# BMW Motorrad USA

## Service Information Bulletin

### **\*\*Notice of Recall 08V-245\*\***

**Subject:** Front brake-disc threaded fasteners

**Sensor-cable routing**

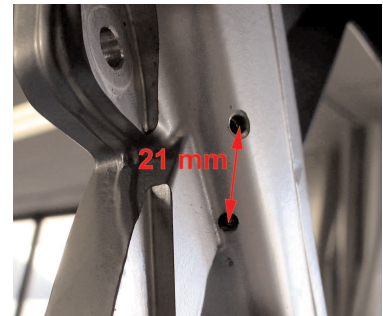
Initially motorcycles were manufactured with raised-head screws, without any change to the routing of the sensor cable. In this case there is a possibility of the cable being damaged when the motorcycle is ridden. The cable routing has to be changed (Measure 1 "Sensor cable routing").

All motorcycles with ABS in range of VINs affected, change the routing of the front wheel-speed sensor cable as described below:

Remove the front wheel (see RSD for details).  
Disengage the sensor cable from the three clips.  
Remove the middle clip (arrow).

Mark and center-punch the new position for the middle clip 21 mm center-to-center from the original hole (arrow) offset toward the outboard side and toward the brake-caliper mount.

### Threaded fasteners and sensor-cable routing

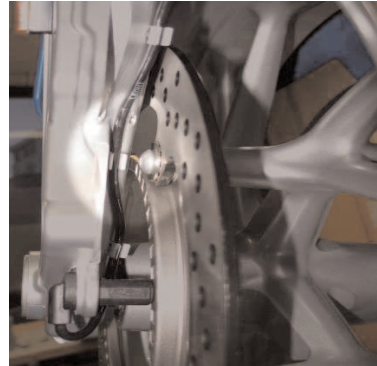
The flat-head screws (M8 x 20mm) used are not long enough to ensure that the fasteners remain secure for the duration of the service life. The threads in the tapped bores of the wheel rim could become stripped. The flat-head screws must be removed and replaced with longer raised-head screws (M8 x 25mm). The routing of the sensor cable also has to be altered (Measure 2 "Threaded fasteners and sensor-cable routing").

In addition, and this applies to all motorcycles (including those without ABS), remove the flat-head screws (M8 X 20mm) on both discs and replace them with raised-head screws (M8 X 25mm).

Remove the screws and install the replacements one at a time (do not remove the entire brake disc). After removing each flat-head screw, clean the threads in the tapped bore and install the new raised-head screw.

Tighten the raised-head screw to 24 Nm.
